December 28, 2004
LIC-04-0132

SUBJECT: Response to Request For Additional Information Concerning the 2003 Steam Generator Inservice Inspection Reports

Response to Request For Additional Information Concerning the 2003 Steam Generator Inservice Inspection Reports

Eggcrate and Tube Support Plate Intersection –
Bottom View with Maximum Stress and Crack Locations

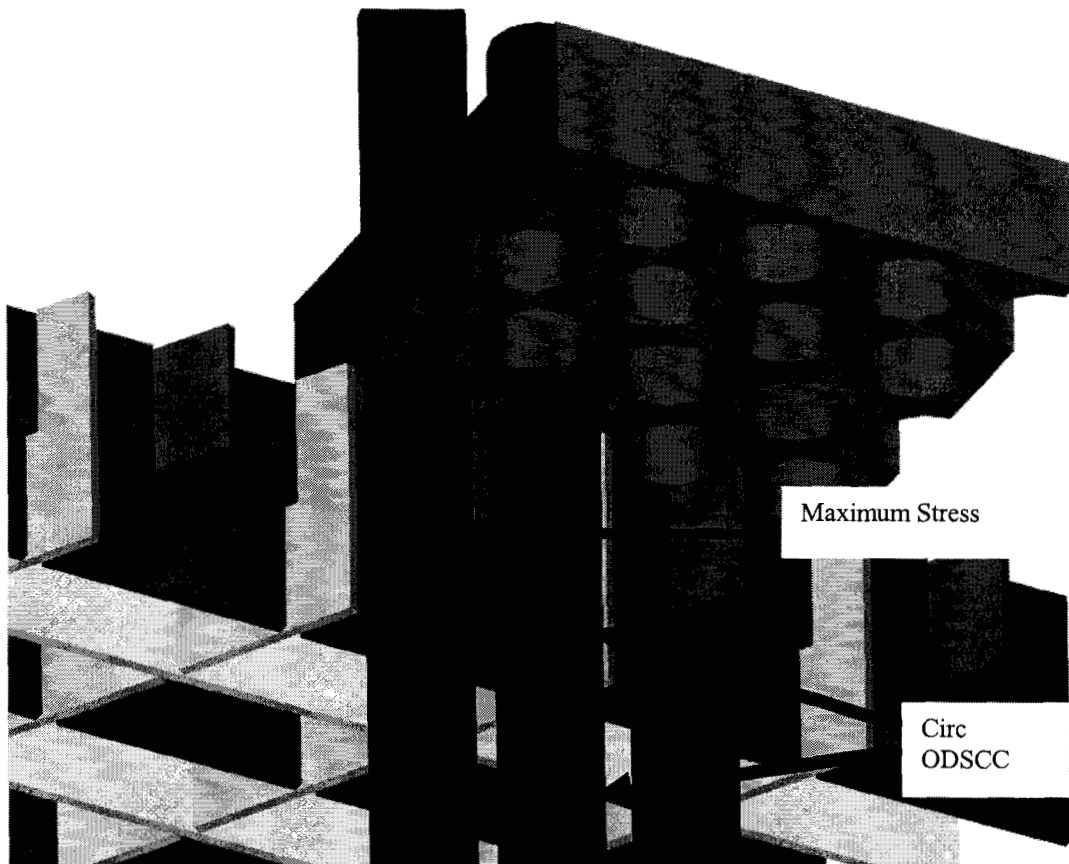
In steam generator B, a single circumferential indication (SCI) was located at the seventh eggcrate support and four SCIs were located in the freespan (areas not encompassed by a support structure). Please discuss any unique circumstances, including dents, associated with these indications and discuss the implications for future susceptibility of the eggcrate supports and freespan region to circumferentially oriented degradation.

A root cause analysis was conducted after the inspection. The indication identified at the eggcrate support is at the chord region (edge) of the partial drilled support plate (see UT results for SG B Row 84 Line 73 listed above in question #1). A second tube (also in the chord region) with a circumferential indication at an eggcrate location was detected in SG B (R87/L52) at support H4 – 1.10". This support structure is also a combination eggcrate / drilled plate assembly. The indication is 0.27 volts with an estimated depth of 33% and an arc length of 21 degrees. The three coil delta probe confirms the presence and orientation of the flaw. The low frequency pancake coil data shows that the flaw is located below the tube support plate and the azimuthal orientation of the flaw is about 120 degrees relative to the eggcrate lattice. Only one lattice bar is evident in the ECT data. This intersection was not included in those tested by UT.

At the top of these eggcrates along the chord the edge of the drilled plate is scalloped and has the shape of a series of semi circles when viewed from the top. Growth of the drilled plate from denting results in a bending strain at and below the eggcrate where the tube is restrained from movement in the lateral plane. This configuration is unique to the chord region and these locations have been identified as a critical area in accordance with EPRI guidelines. The February 2005 examination will include plus point coil testing of 100% of this critical area.
